Response to the reviewer 2 of the manuscript: “Comparison of different droplet measurement techniques in the Braunschweig Icing Wind Tunnel” by Inken Knop et al.

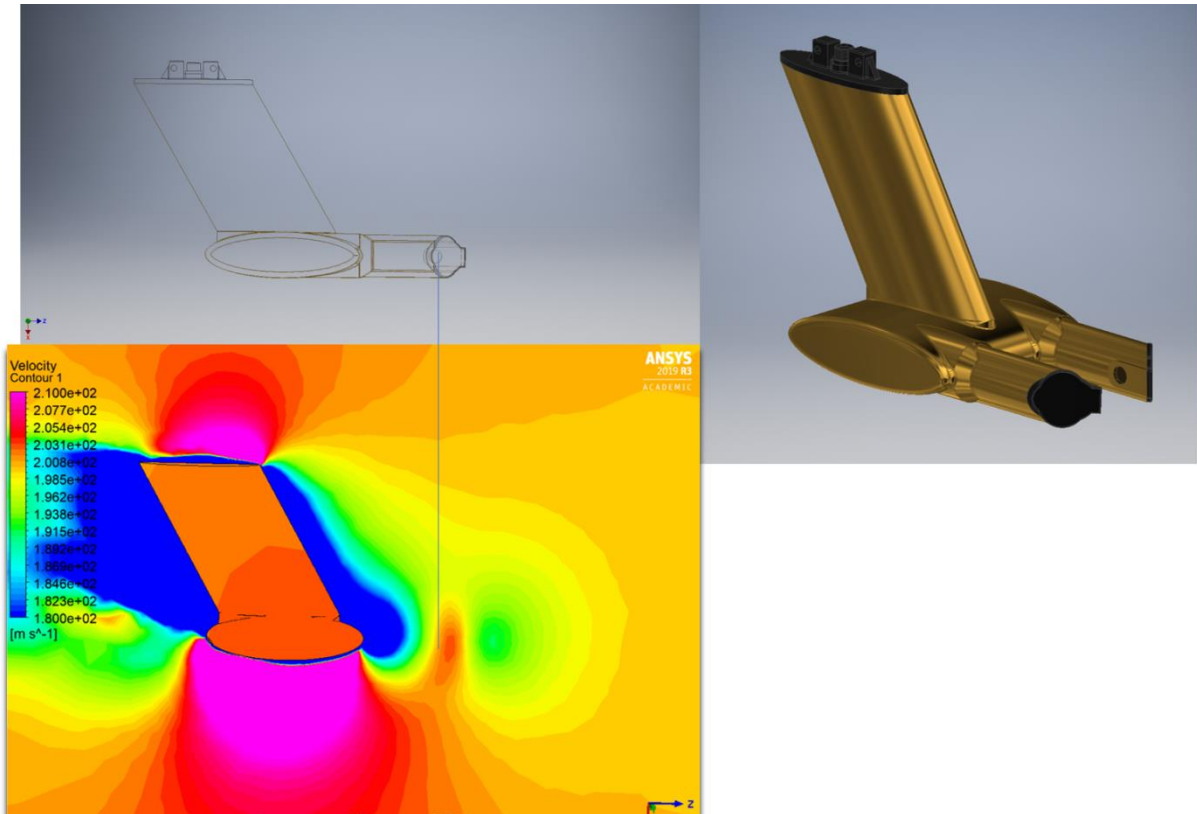
1396-397: “A low sensitivity of the FCDP to larger particle sizes ($> 30 \mu\text{m}$)the PDI for large droplets” : what makes you think that FCDP has a low sensitivity to particles larger than 30 μm ? Is it a well-known behavior of the FCDP probe? If yes, could you provide references supporting this assertion?

Response: There are indeed hints of a lower sensitivity of the FCDP towards larger particles throughout various measurements, when comparing FCDP to CDP data e.g. ACTIVATE (current and ongoing NASA campaign) or in further wind tunnel tests with a FCDP, 2D-S combination at RTA, (Vienna, Austria) during the ICE GENESIS campaign. Unfortunately there is now reference available yet. A hint is available is the study by Thornberry et al. (2016), where the authors only use 12 size bins (out of the 21) up to only 24 μm for data evaluation. Larger sizes are covered by a 2D-S probe with a diode array resolution of 10 μm . Sizing (and imaging) capabilities of imager probes in this size range is subject to large errors (Baumgardner et al., (2017), ...). Thornberry et al. (2016) even says while comparing the size range between 24 μm -36 μm of FCDP and 25 μm -35 μm of 2D-S respectively,

“This change (projected area of measured particles by 2D-S and FCDP) in the relationship between the FCDP and 2-D-S is due to a greater decrease in the particle concentration measured by the FCDP in the 24–36 μm size range than that measured by the 2-D-S in the 25–35 μm bin.” So the change in his linear fit over the median projected area σ in FCDP measurements is attributed to a lower number concentration of larger particles $>24\mu\text{m}$ compared to what the 2D-S has observed in the given size range.

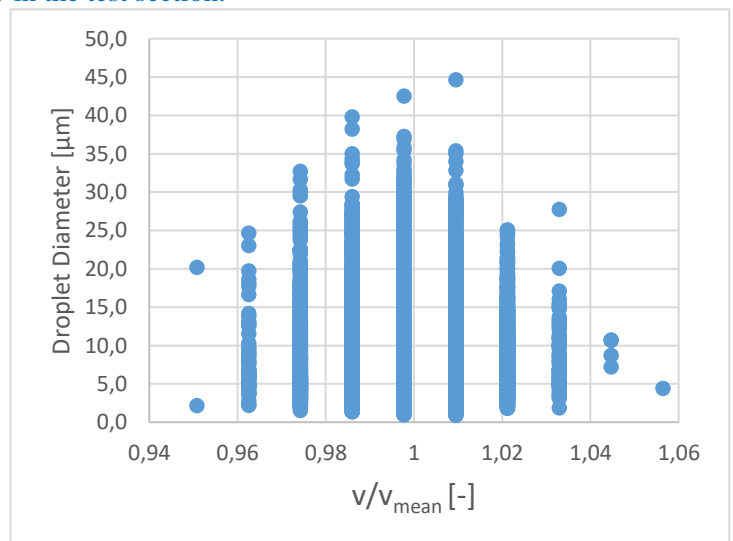
Secondly, the argued velocity deficit for large droplets is hardly convincing: on fig 10 the density looks equally spread around unity for droplets below 50 μm (as far as I can see on my grey-printed scale picture).

Response: We compare velocity measurements from the PDI, a completely non-intrusive measuring technique, with an intrusive technique. With a surface area of the test section of 50cm x 50cm and a projected surface of the FCDP of approximately 171.69 cm^2 almost 7% ! of the cross sectional area are occupied by the probe itself, without taking a boundary layer within the test section into account (reducing the cross section by an assumed boundary layer thickness of 1cm yields a relative FCDP cover of 8%). Without assessing the stream lines around the FCDP and droplet trajectories in detail we might have to consider this effect, especially when comparing different measurement techniques. The figure below shows the velocity field across the centre plane through the SA, around a FCDP at a given true air speed of 200 m/s. Although our measurements were conducted at a lower TAS, we want to draw

the attention towards the point that the velocity field along a potential particle trajectory ahead of the probe arms, as well as directly where the SA is located is modified by the probe itself. This fluid simulation was conducted in a free flow environment and without the constraint of a test section. Velocity measurements with the PDI on the other hand are unobstructed and undisturbed by the probe itself.

Simulated droplet speeds for this specific wind tunnel setup vary with droplet diameter. According to this simulation this effect is pronounced for larger droplets (>100µm).

Ansys simulation results for single droplets accelerated with the 3D-airflow of the wind tunnel nozzle show for droplets >150µm a velocity deficit of 10% in the test section.

In addition to the particle velocity plot (figure 2) we show in the above image the PDI velocity measurement results of a test case with only small droplets. The maximal velocity deficit is less than 5%.
